Access Compliance Report

Public Rights-of-Way

(Curb Ramps)

Intersection ID: 5420	Main Street: CARVER_PL	Cross Street: ROCKWELL_BV_WEST	Location: N
ADA ID: 3ACFCA6E6035	Ramp Type: Para	Initial Pass/Fail: Fail	Overall Compliance: No
Severity Score: 21.25			
Codes/Mitigation Info/Possible Solution		Field Measurements/Component Compliance

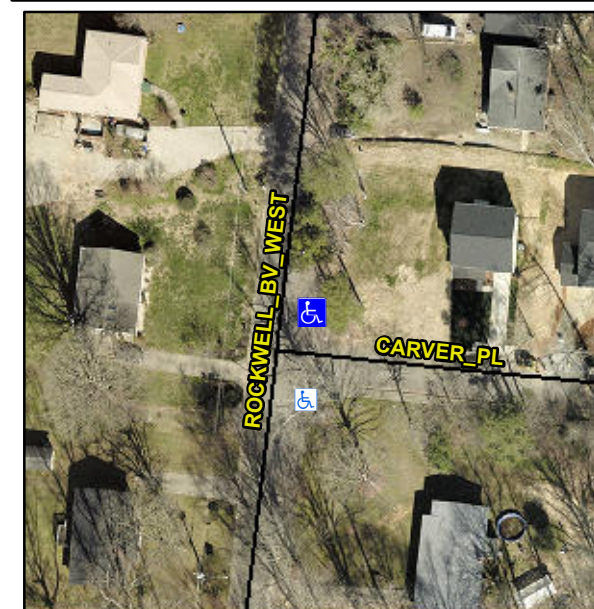
LT RP < 5%

R304.5.1, R304.3.2

Compliance	Description	Data	Compliance	Description	Data
N/A	Ramp Length LT (in)	61.0	N/A	Ramp Length RT (in)	64.0
Yes	Ramp Width LT (in)	60.0	No	Ramp Width RT (in)	36.0
Yes	Ramp Slope LT (%)	4.7	No	Ramp Slope RT (%)	8.8
Yes	Ramp XSlope LT (%)	0.7	Yes	Ramp XSlope RT (%)	1.7
N/A	Landing Length (in)	N/A	N/A	DWS Provided?	N/A
N/A	Landing Width (in)	N/A	N/A	DWS Contrast?	N/A
N/A	Landing Slope (%)	N/A	N/A	DWS Length (in)	N/A
N/A	Landing X Slope (%)	N/A	N/A	DWS Full Width?	N/A
N/A	Landing Curb? (Y/N)	N/A	N/A	DWS Offset (in)	N/A
N/A	Shared Landing?	N/A			
N/A	Gutter Ponding?	N/A	N/A	Gutter Slope (%)	N/A
N/A	Gutter Lip Ht (in)	N/A	N/A	Gutter X Slope (%)	N/A
N/A	Painted X Walk1?	No	N/A	Painted X Walk2?	N/A
	X Walk 1 Direction	To S		X Walk 2 Direction	N/A
N/A	X Walk 1 Width (in)	N/A	N/A	X Walk 2 Width (in)	N/A
	X Walk 1 Slope (%)	3.5		X Walk 2 Slope (%)	N/A
	X Walk 1 X Slope (%)	1.6		X Walk 2 X Slope (%)	N/A
N/A	Ramp inside XWalk1?	N/A	N/A	Ramp inside XWalk2?	N/A

Remove & Replace Entire Ramp.
